## City of Ketchum Planning & Building

### ADMINISTRATIVE FLOODPLAIN DEVELOPMENT PERMIT AND RIPARIAN ALTERATION PERMIT TEMPORARY CONSTRUCTION ACTIVITIES

<b>PROJECT:</b>	Carbon Hill Hot Springs Vault and Truss Repair and Reconstruction
<b>FILE NUMBER:</b>	P23-075
<b>OWNER:</b>	Carbon Hill Hot Springs Inc.
<b>REPRESENTATIVE:</b>	Bruce Smith, Alpine Enterprises
<b>REQUEST:</b>	Request to permit temporary construction related activities for vault repair and truss reconstruction within the riparian setback and the floodplain
<b>LOCATION:</b>	Tax Lot 6048 (RP1M0000000220)
<b>ZONING:</b>	Tourist-4000 (T-4000) and Agricultural and Forestry (AF)
<b>OVERLAYS:</b>	Floodplain Management Overlay with Waterways Design Review Subdistrict
<b>REVIEWERS:</b>	Morgan Landers, AICP – Director of Planning and Building
<b>NOTICING:</b>	None required

A SITE & CONSTRUCTION ACTIVITY PLAN SHOWING  
HOT SPRINGS LODGE, CLIMAX & CARBON HILL MILLSITES  
WITHIN S15, T.4N., R.17E., B.M., CITY OF KETCHUM, BLAINE COUNTY, IDAHO  
PREPARED FOR CARBON HILL HOT SPRINGS INC.

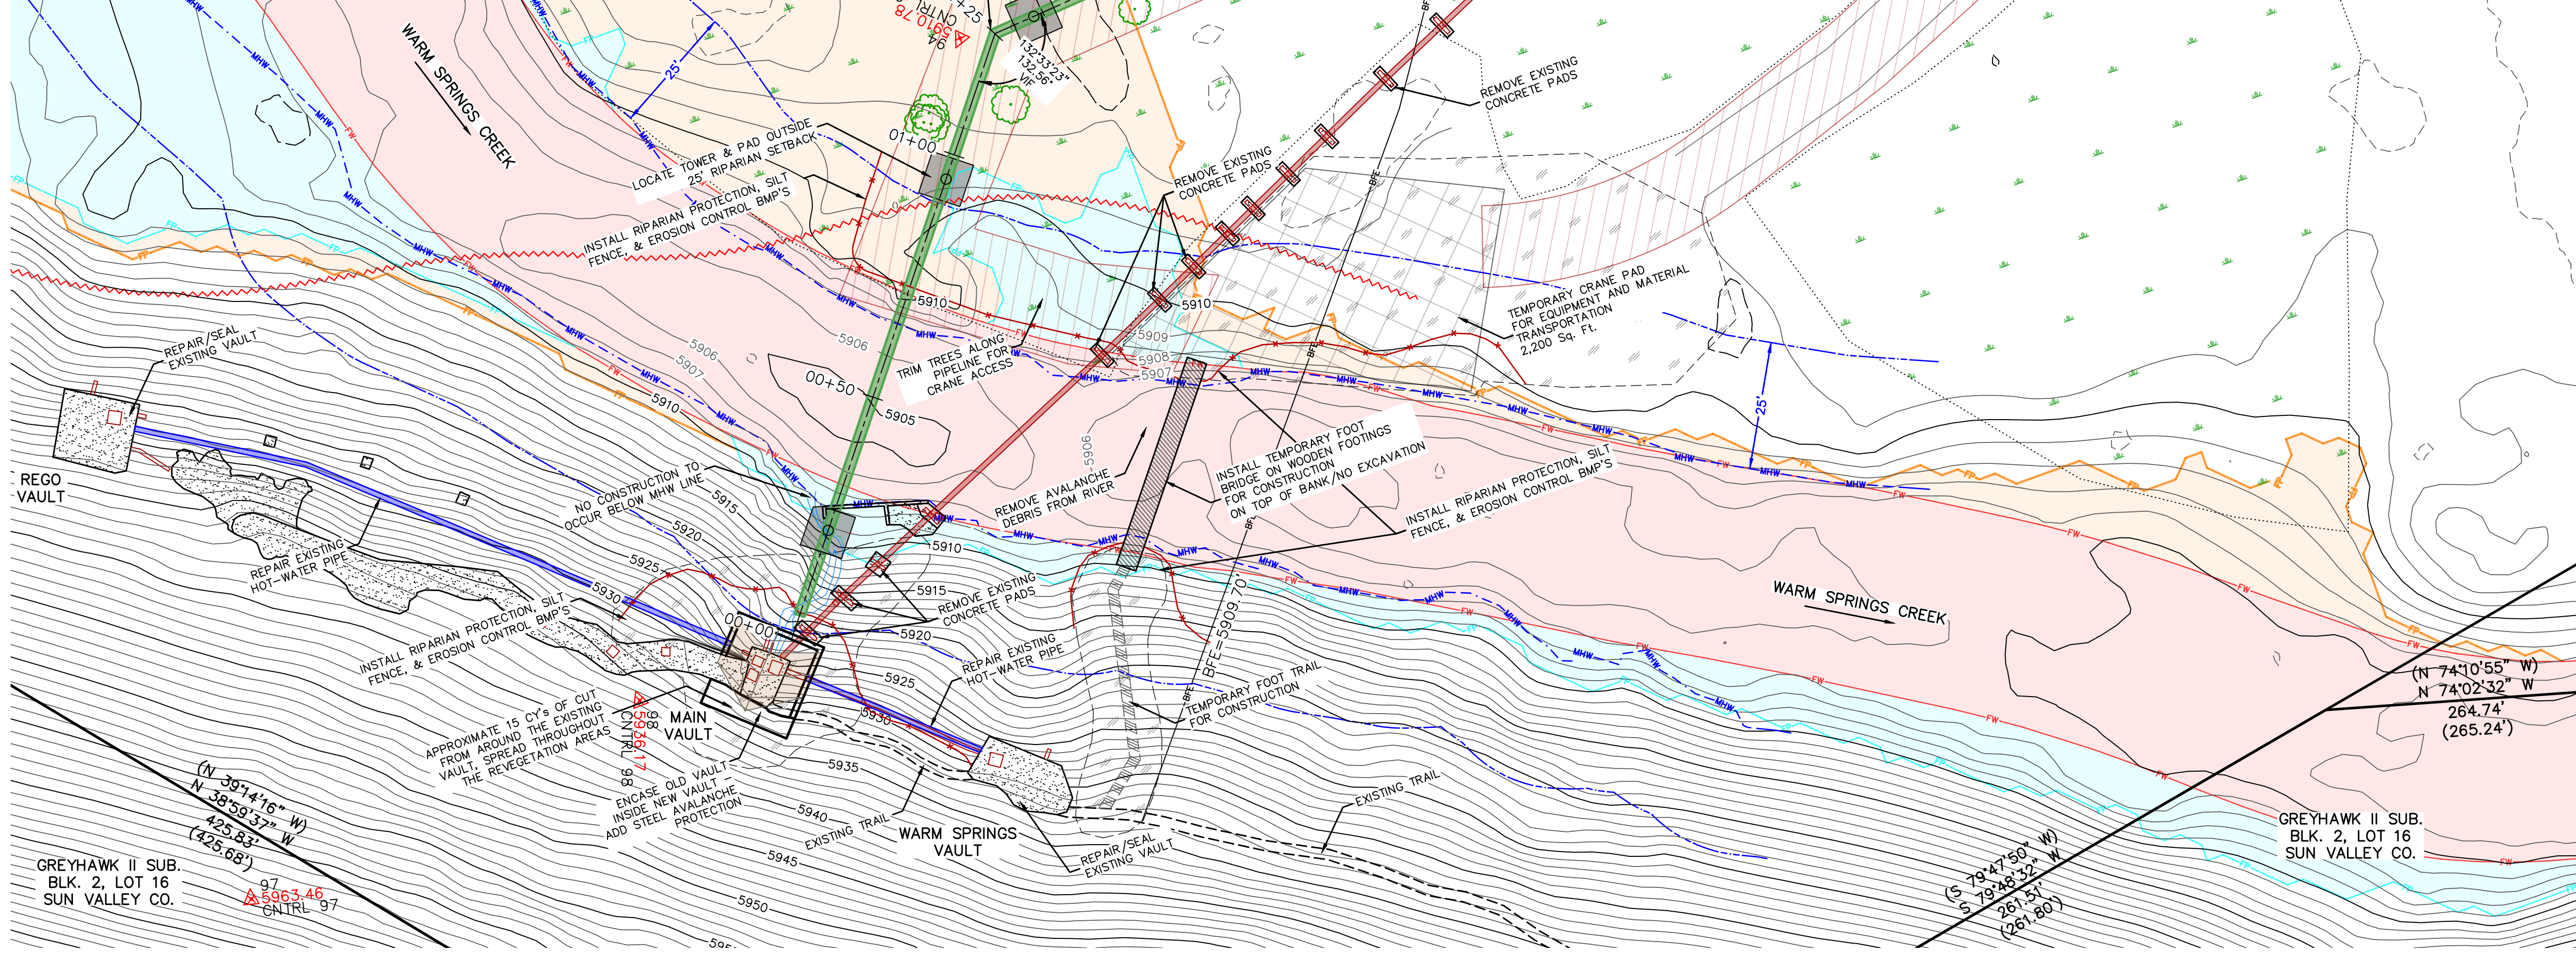
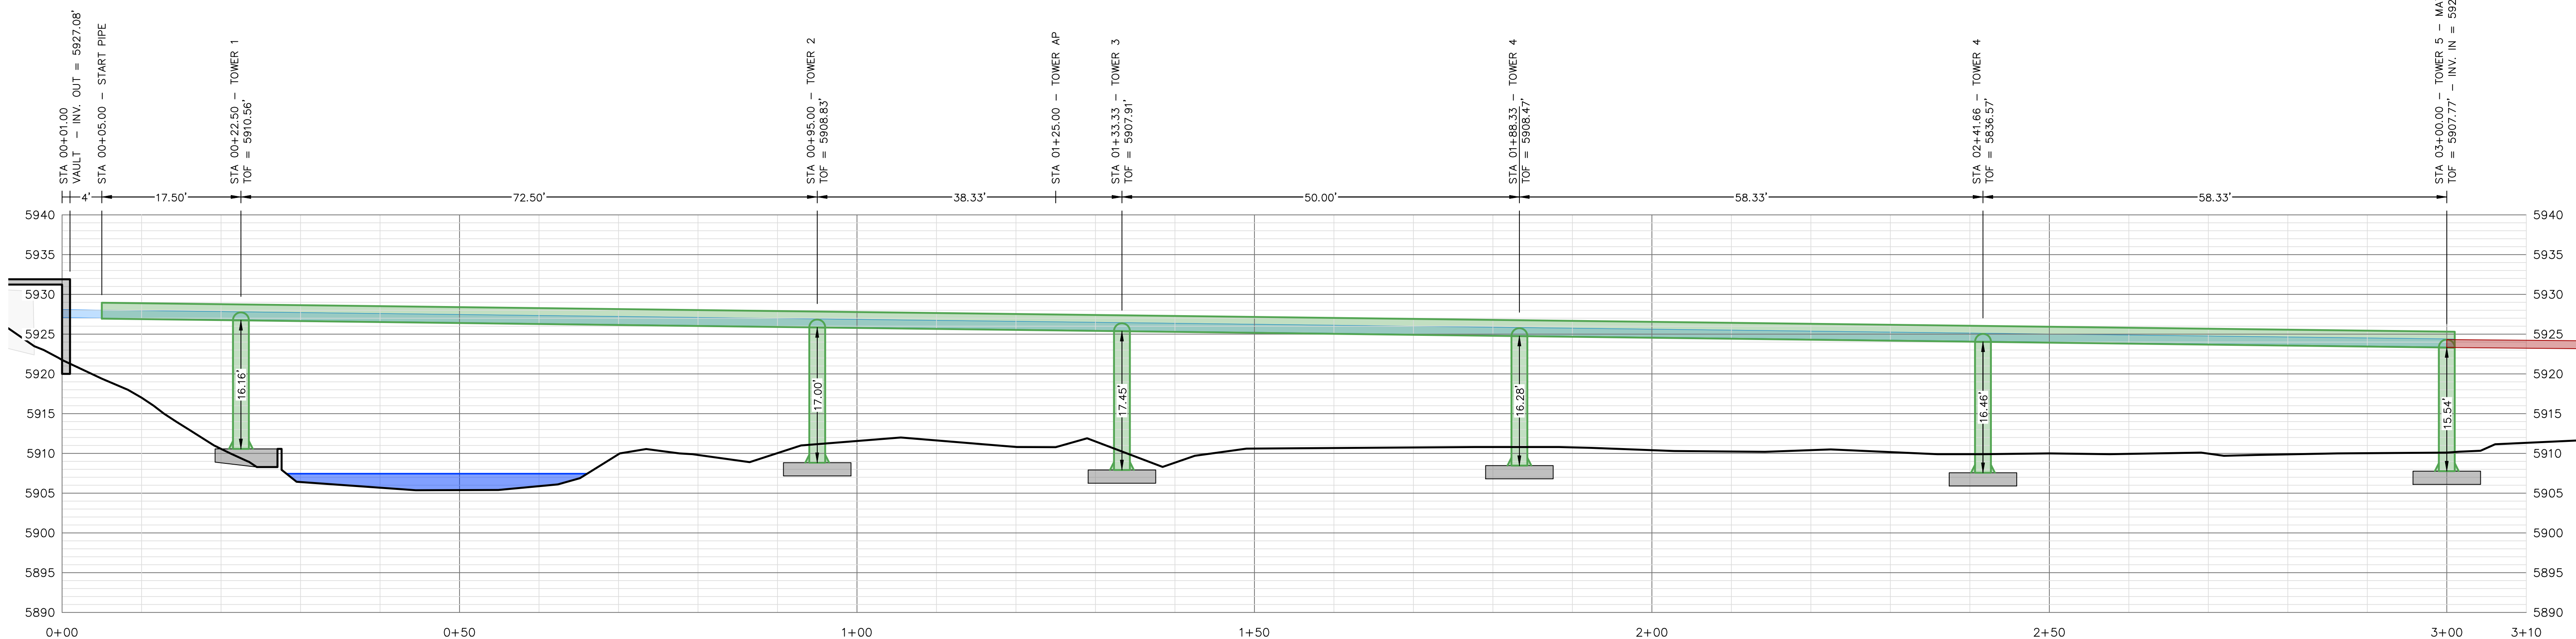
6. The owner's representative shall notify the Planning and Building Department via phone, 208-726-7801, 48 hours in advance of the day construction of the project is scheduled to begin to facilitate a site visit to ensure the straw waddle and fencing protecting the riparian zone has been installed per sheet A003.
